**TOWN OF NEWBURGH
PLANNING BOARD
TECHNICAL REVIEW COMMENTS**

PROJECT NAME: KINGDOM HALL
PROJECT NO.: 22-31
PROJECT LOCATION: 33 LITTLE BRIATIN RD
SECTION 97, BLOCK 3, LOT 13
REVIEW DATE: 30 DECEMBER 2022
MEETING DATE: 5 JANUARY 2023
PROJECT REPRESENTATIVE: GREENMAN PATTERSON

TYPICAL PARKING SPACE DETAIL

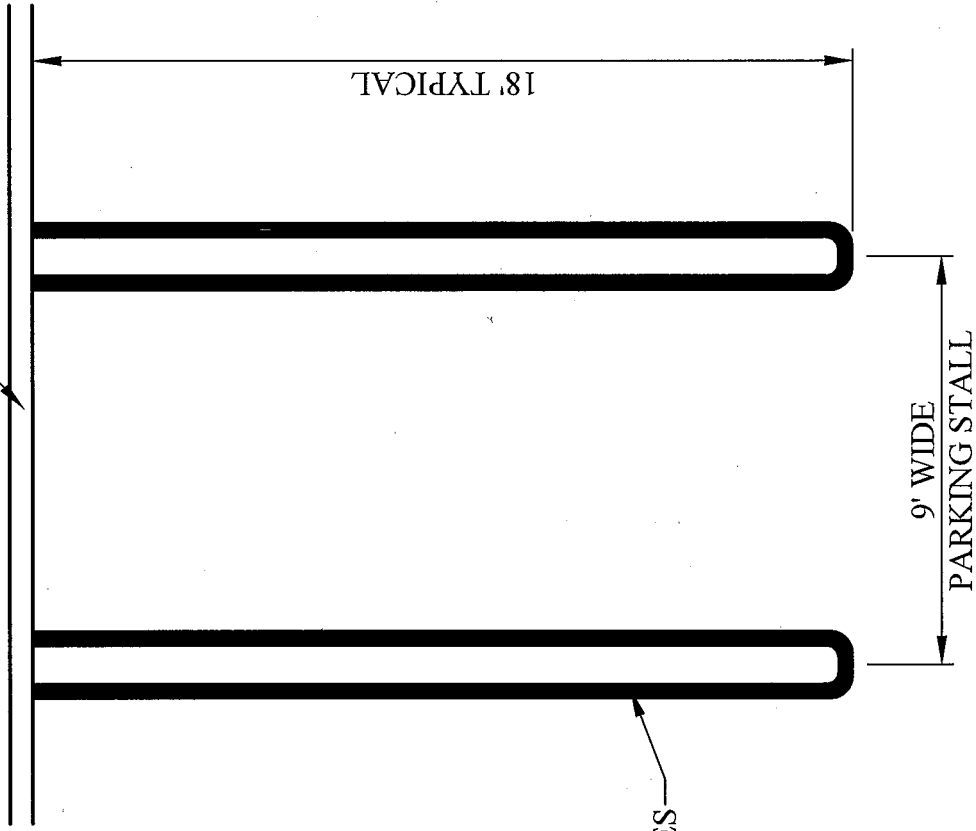
9. The Town of Newburgh requires double striping of the parking spots. (Detail Attached)
10. Numerous curb details are included; the actual curb details to be utilized should be placed on the plans.
